COLORADO
Division of Reclamation,
Mining and Safety
Department of Natural Resources

Re: Lorencito Canyon Mine, Second review of 2018 ARR

Figure 1

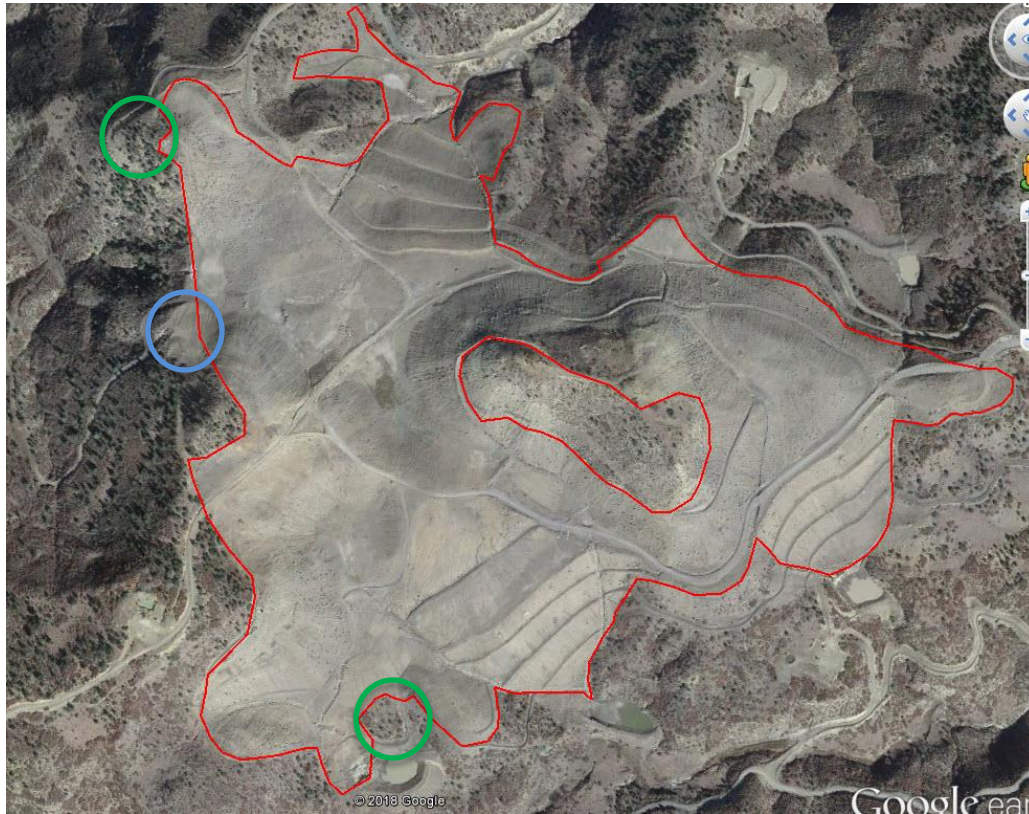
1. The actual disturbance area outline (bright green polygon) on Map 2.05.3-5 of the NECC response appears to be incorrect as follows:
 - a. Comparing that outline to Google Earth, it looks like the outline may be too extensive in some areas. For example, at the northwest corner, the "nose" of the outline appears to extend too far west. Also, north of Pond 6 (aka Pond 006a) the outline may encompass undisturbed area.
 - b. In other parts of the site, the outline may not encompass enough disturbed area. For example, the area west of the sediment dumping area appears disturbed but is not within the boundary. For this area and any others, please indicate if the disturbance area outline is impacted by pre-mining disturbances.
 - c. Additional areas should be shown as disturbance on this map. This includes ponds, roads to ponds, ditches (such as D4, D15, and D76), and area BA-3.

Please see the following figure (Figure 1). The red polygon is my attempt to use Google Earth to identify the outline of the disturbance (not including BA-3 or the ponds, roads, and ditches that are outside the "main" area). The green circles are areas where the NECC disturbance boundary (in Nick Mason's Map 2.05.3-5) appear to be too extensive. The blue circle is where the NECC boundary may not be extensive enough. Please let me know if the intent of this figure is not clear.
